ITEM 5.1 (b)

85 Harrington Street
The Rocks
GOLDEN AGE & HANNAS THE ROCKS

TITLE
RESPONSE TO DoPE
ITEM 5.1 (b)

SHEET NO. 037

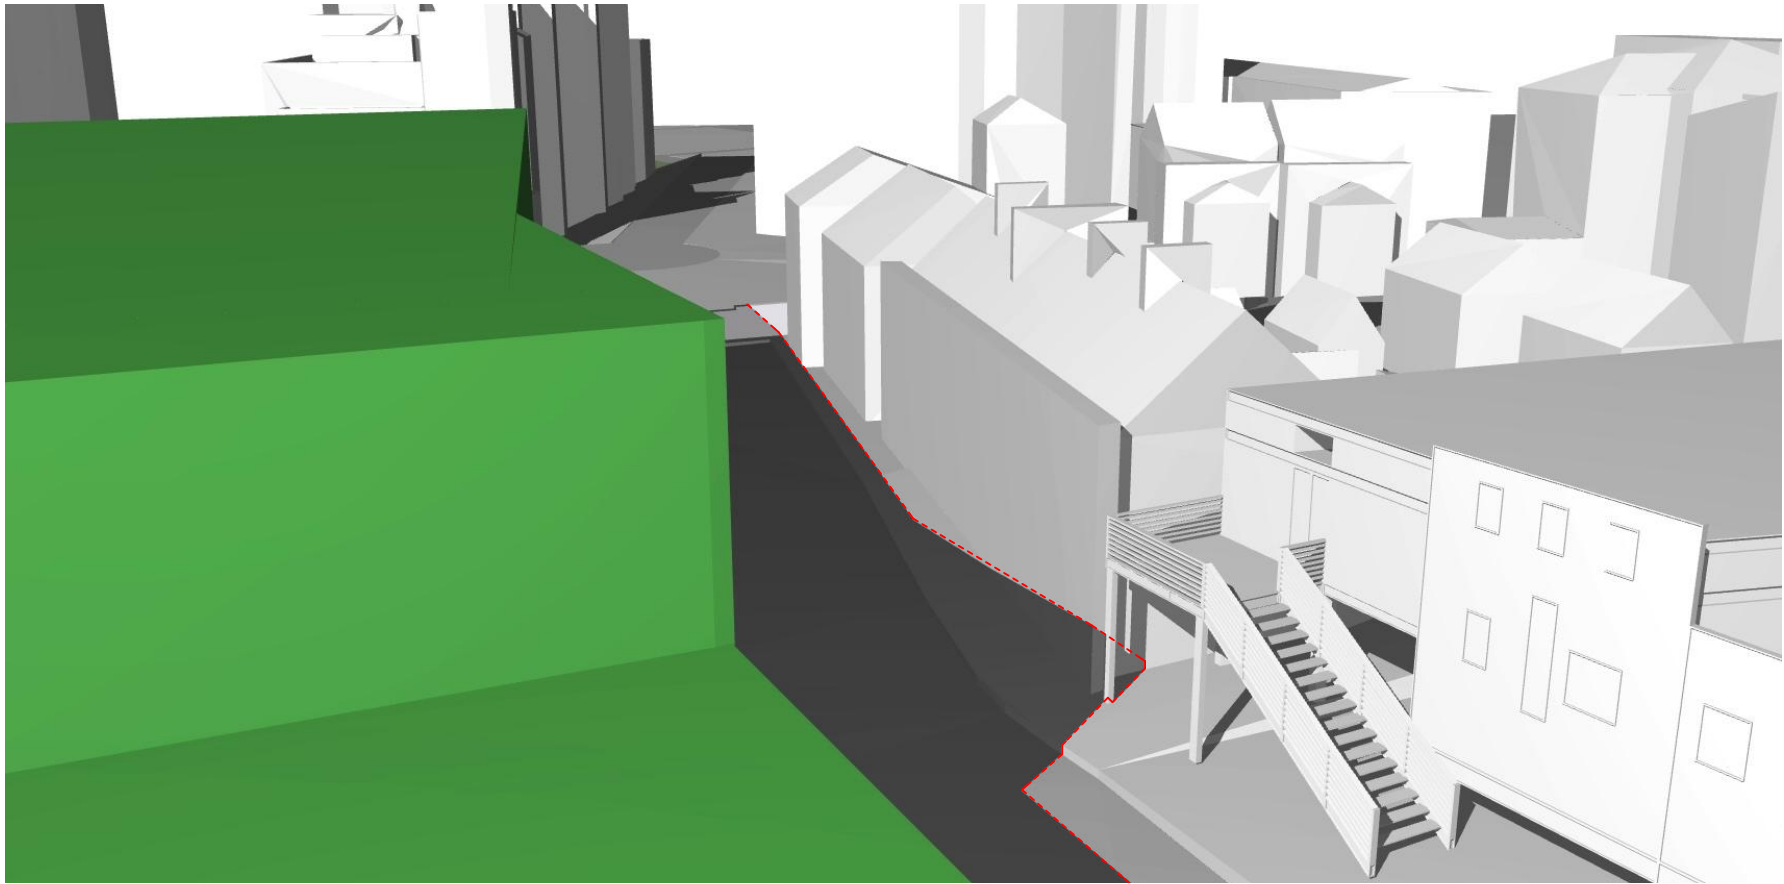
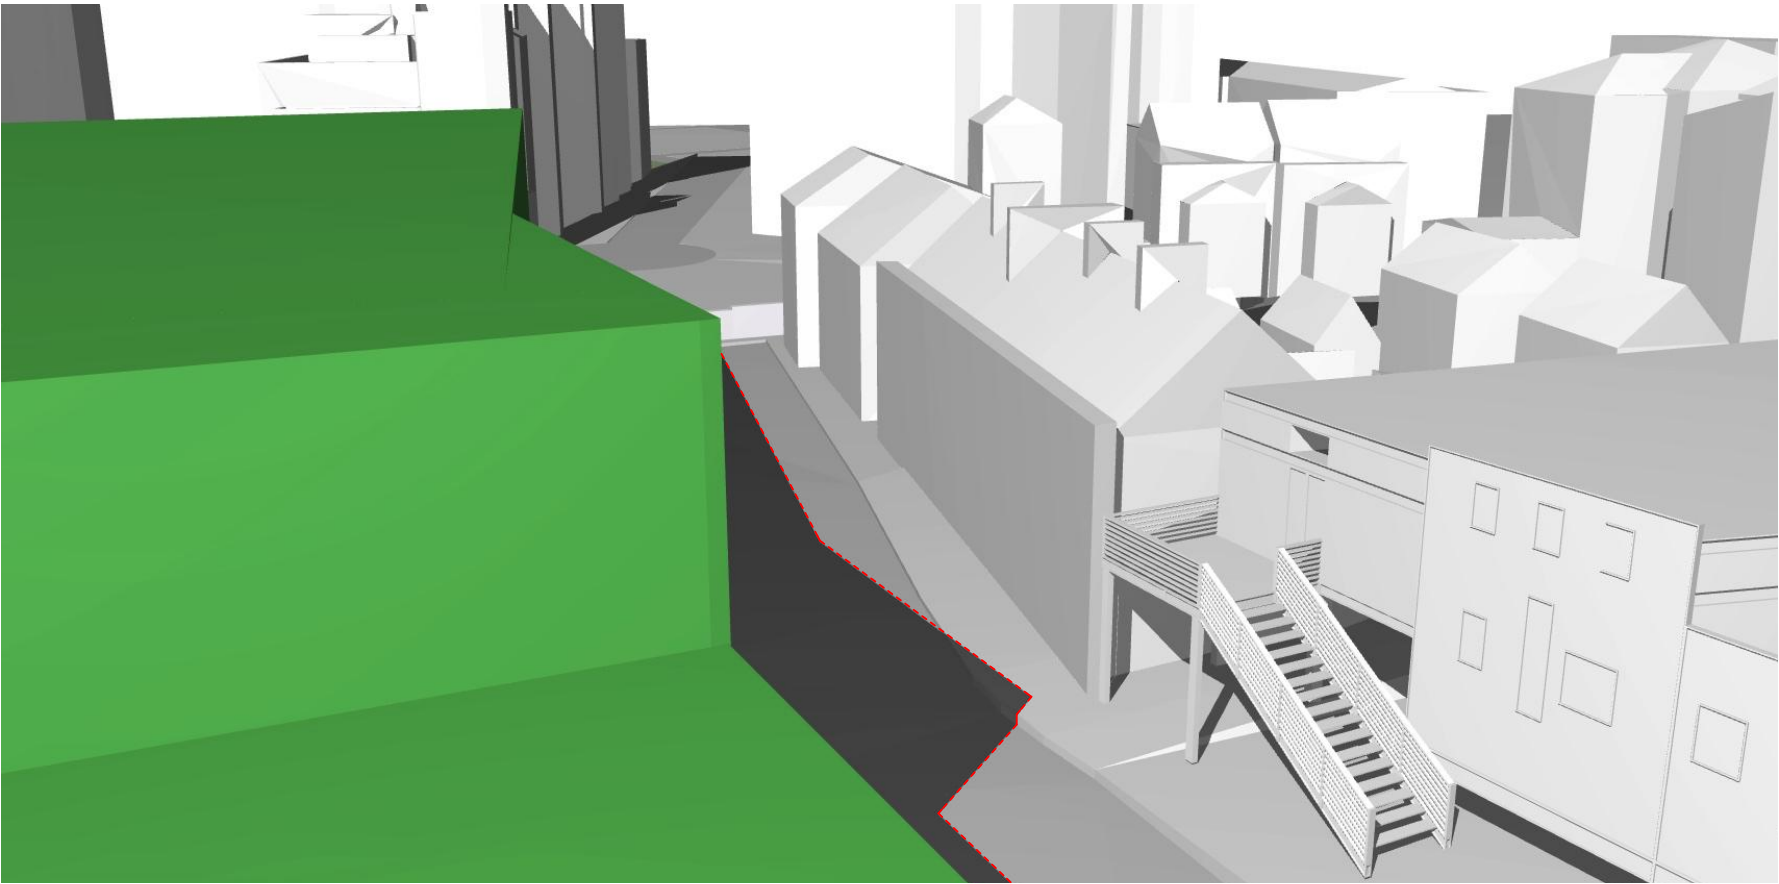
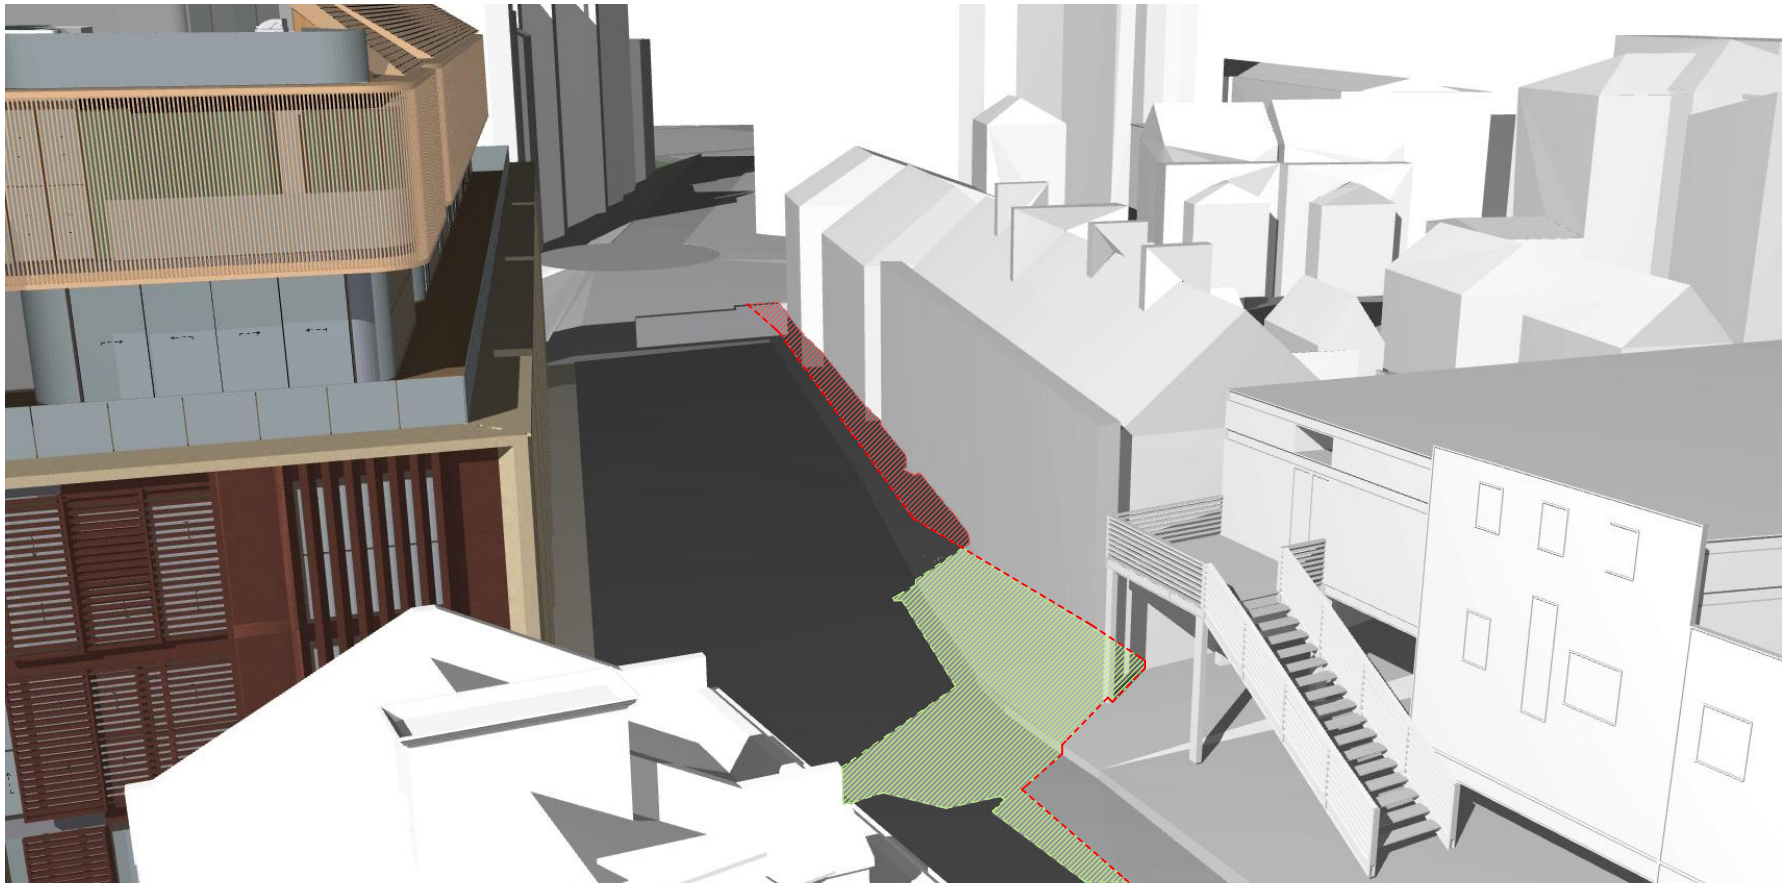
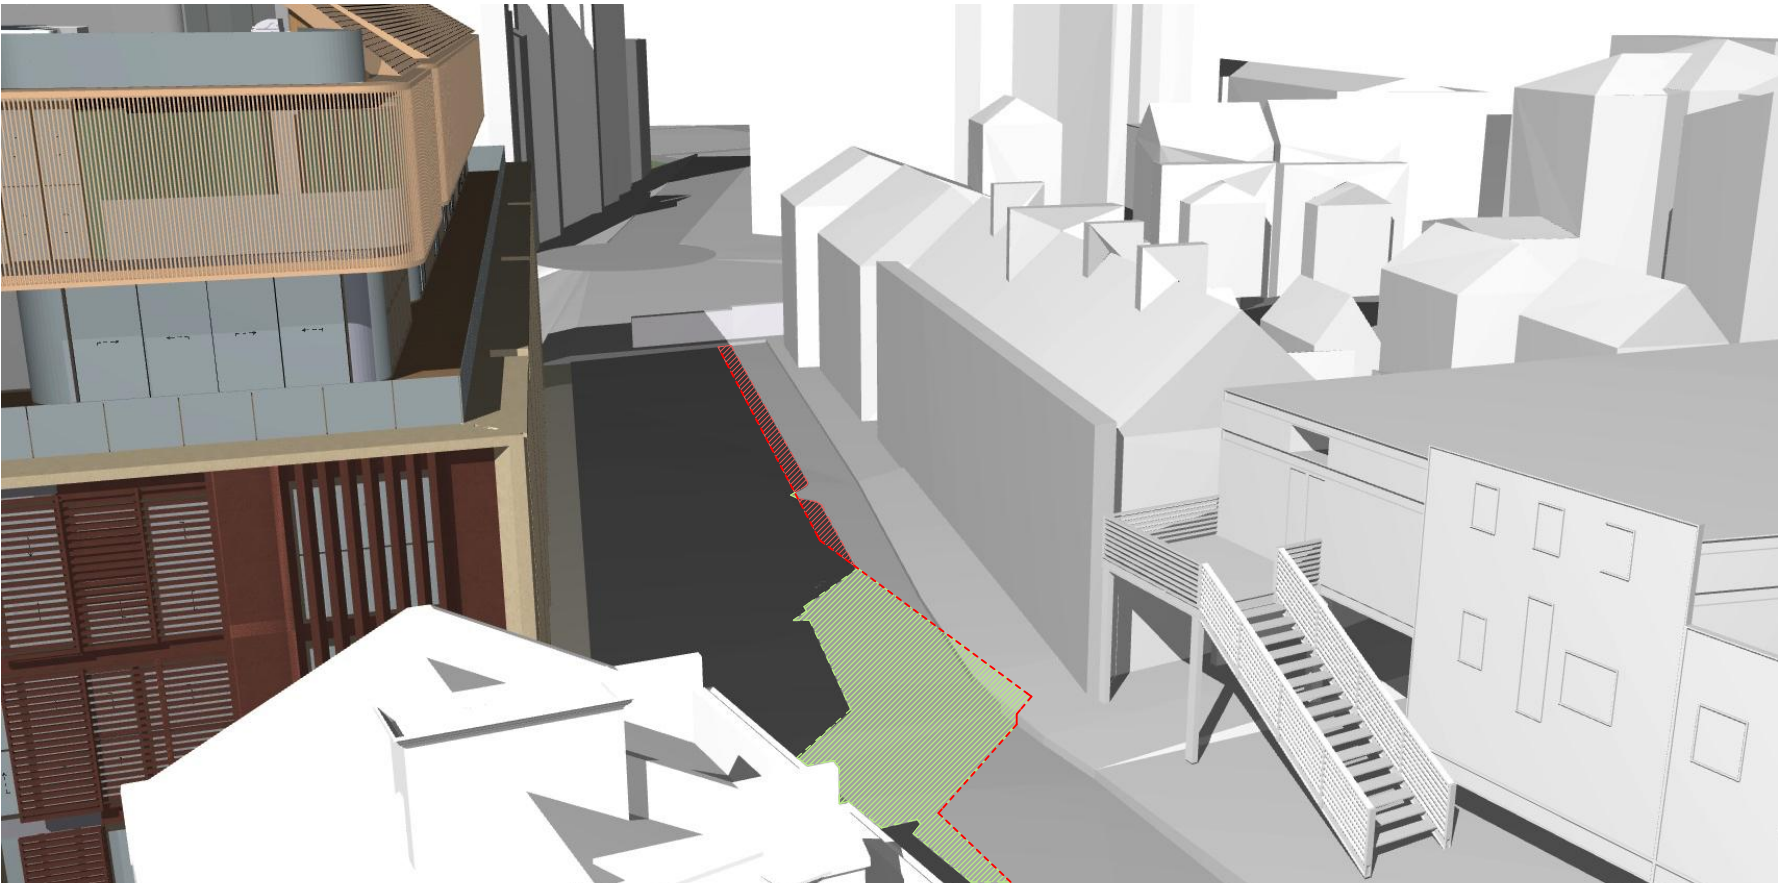
Issue/ Objection:
Solar Impact/
Overshadowing

Description:
Revised and enlarged 9am mid-winter elevational shadow diagrams clearly illustrating the extent of overshadowing compared to a SCRA compliant scheme. 9:30am diagrams should be provided if any shadow increase to neighbouring properties in Gloucester Street will occur at 9am

Response
Revised diagrams have been provided showing overshadowing impacts for Gloucester Street. These have been provided at both 9am and 9:30am for both March, June, September 21. The analysis concludes that the development largely improves on a SCRA compliant scheme.

- Notes:**
- Minor increase in shadow outside of SCRA envelope extent at 9am
 - No additional shadow cast on Gloucester terraces at 9:30am
 - Full solar access to Gloucester Terraces at 9:30am
